**FINAL
INTEGRATED GENERAL REEVALUATION REPORT AND
ENVIRONMENTAL IMPACT STATEMENT**

CANAL 111 (C-111) SOUTH DADE COUNTY, FLORIDA

**US Army Corps
of Engineers**
Jacksonville District
South Atlantic Division

**FINAL
INTEGRATED
GENERAL REEVALUATION REPORT
AND
ENVIRONMENTAL IMPACT STATEMENT**

C-111 BASE MAP
 FIGURE 1-2

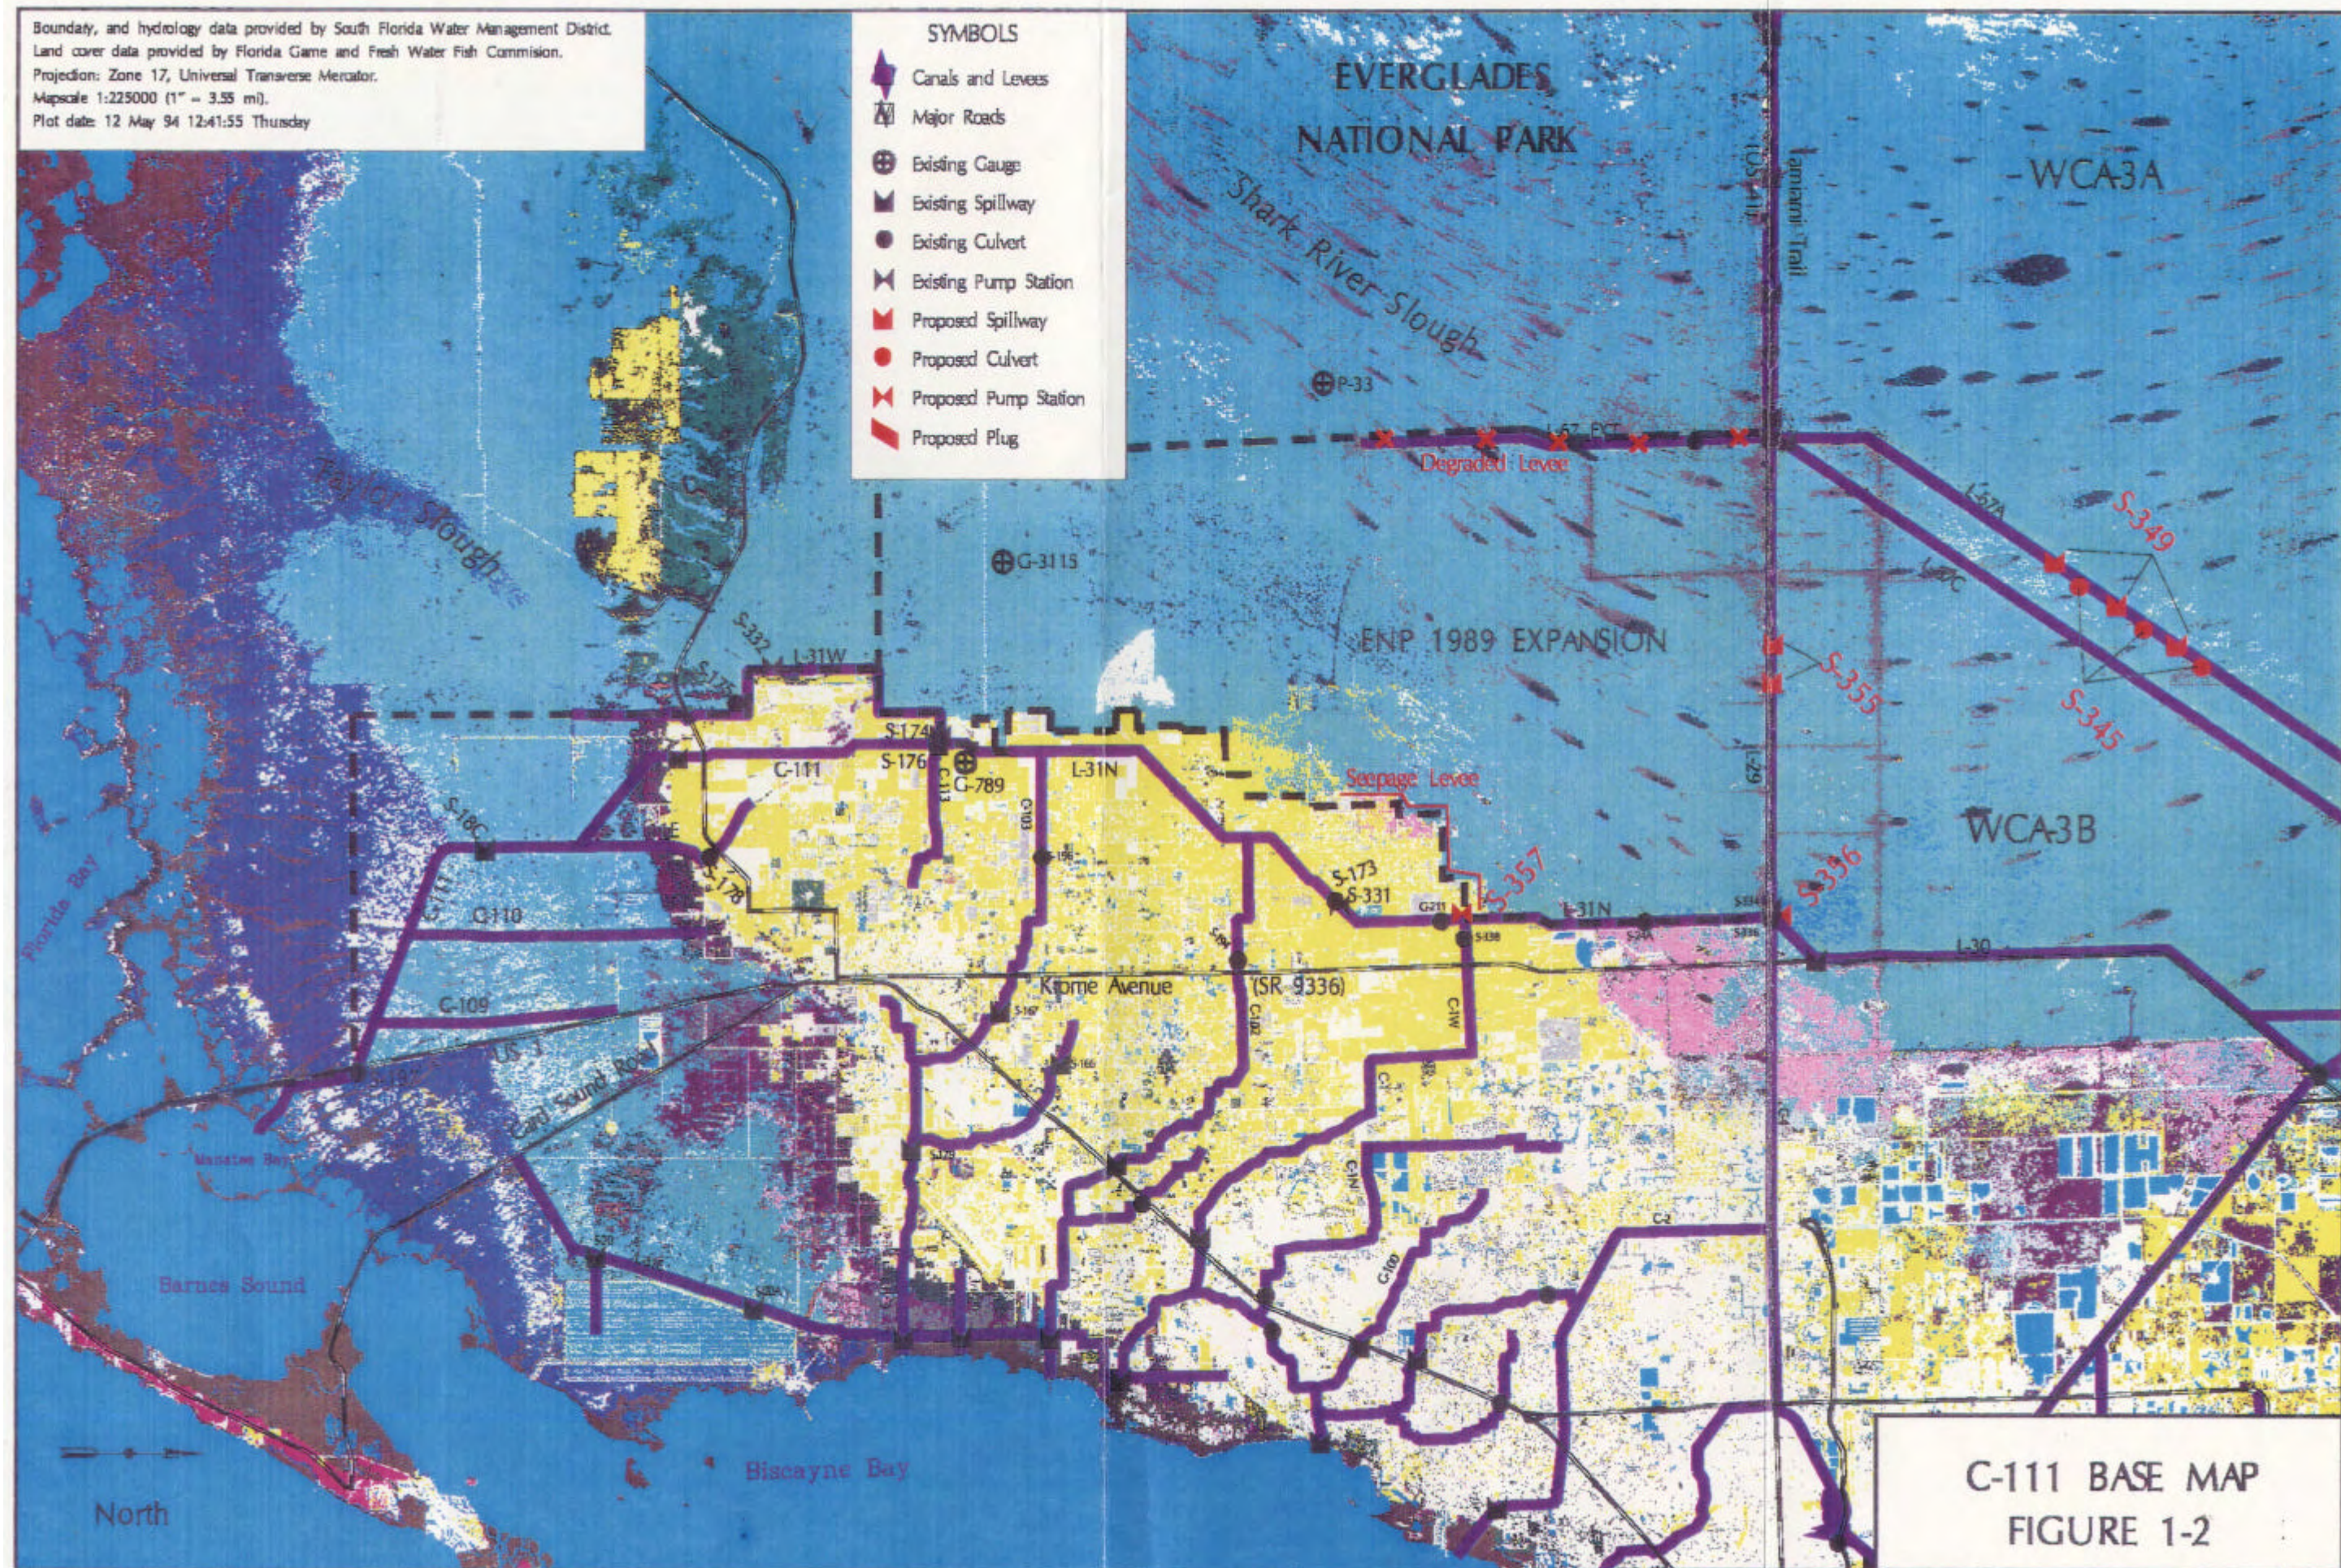
Page 5 of the preliminary draft report was in error. The study basin's northern boundary is a line drawn east from S-331, the divide control structure, and west on the southern limit of the eight and one half square mile area. The map in Figure 1-2 correctly displays the study area.

FIGURE 5-23

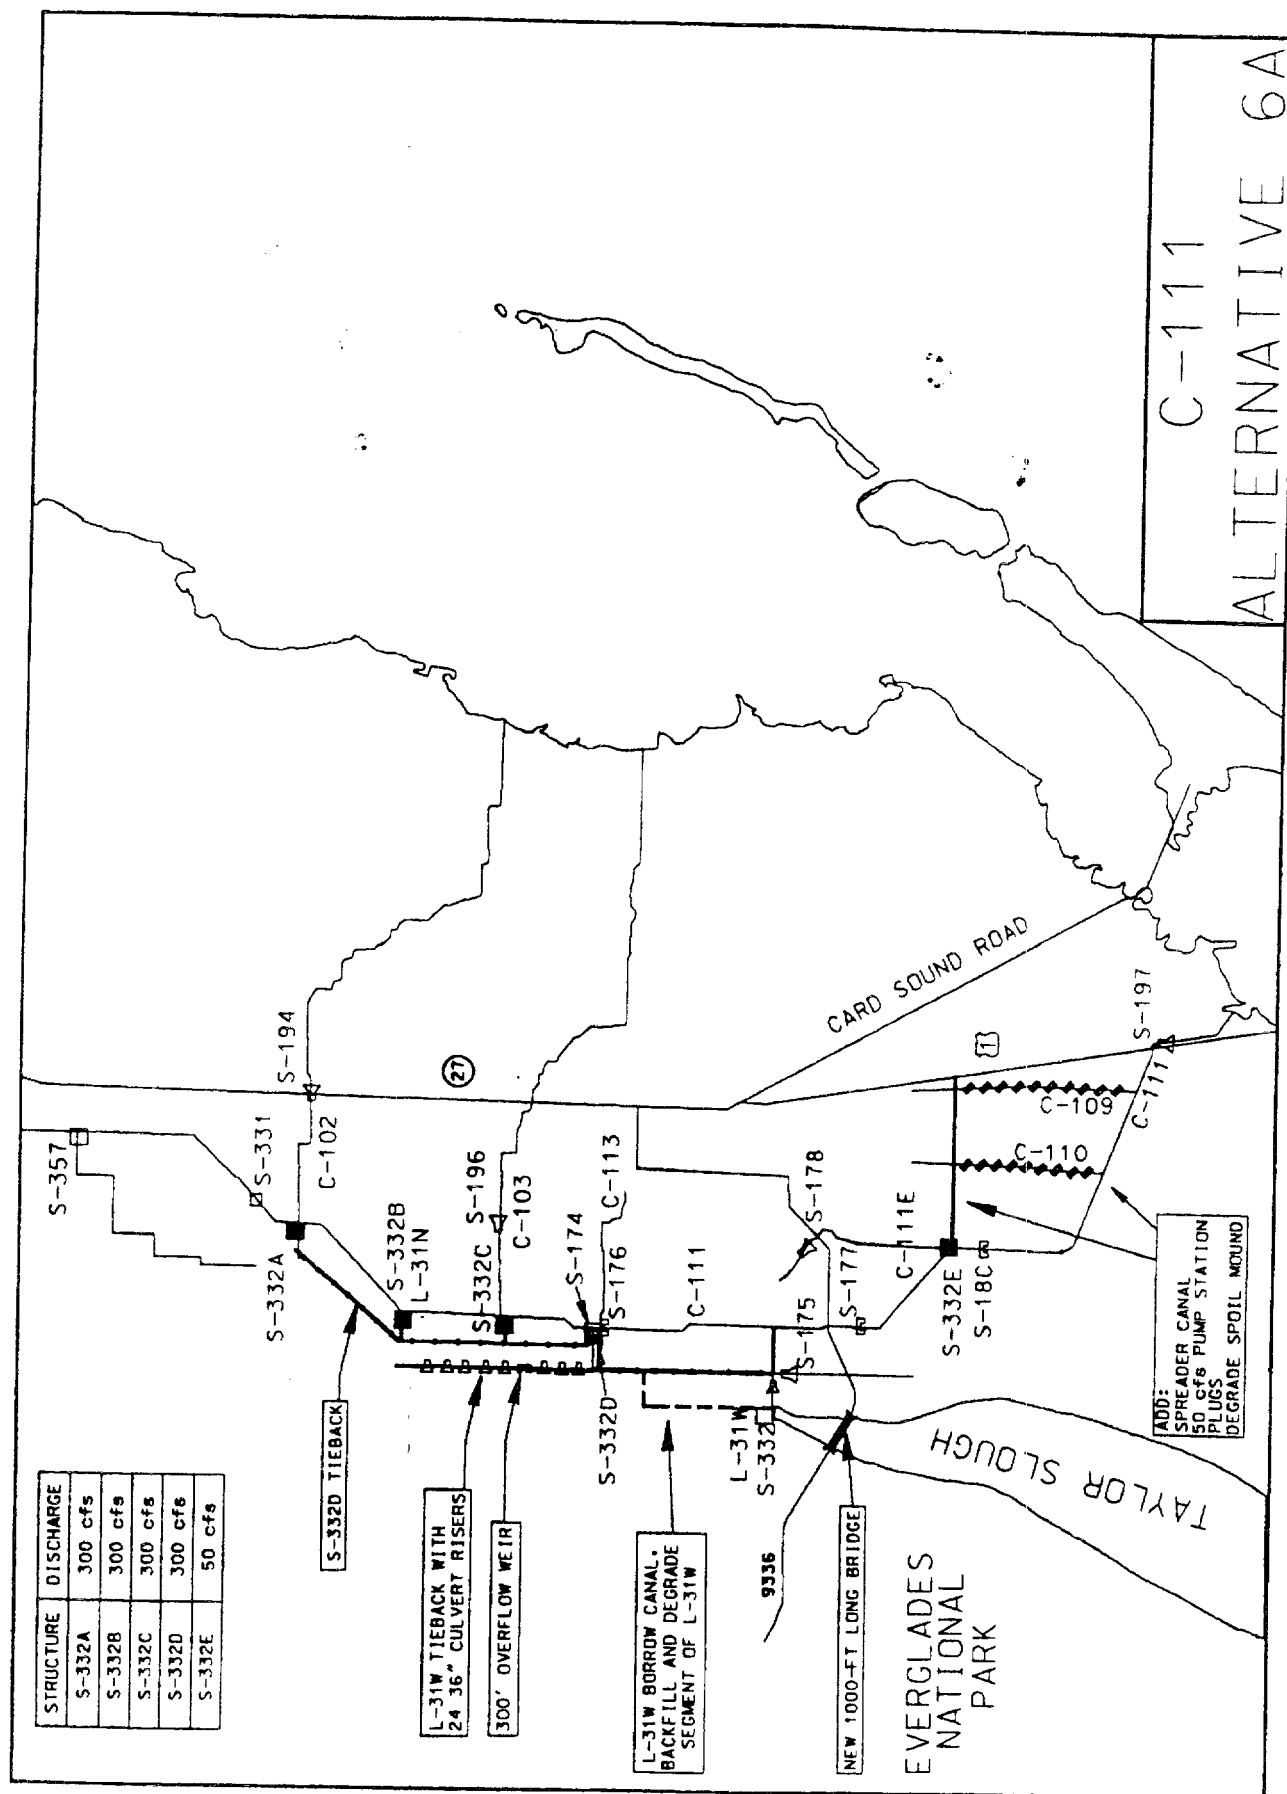
Figure 5-23 indicates that a new, 1000 foot bridge will be required to replace the existing bridge across Taylor Slough. There is no basis for determining this bridge length. Where did the 1000 foot length come from? Is it necessary to be that long?

Figure 5-23 indicates that a new, 1000 foot bridge will be required to replace the existing bridge across Taylor Slough. There is no basis for determining this bridge length. Where did the 1000 foot length come from? Is it necessary to be that long?
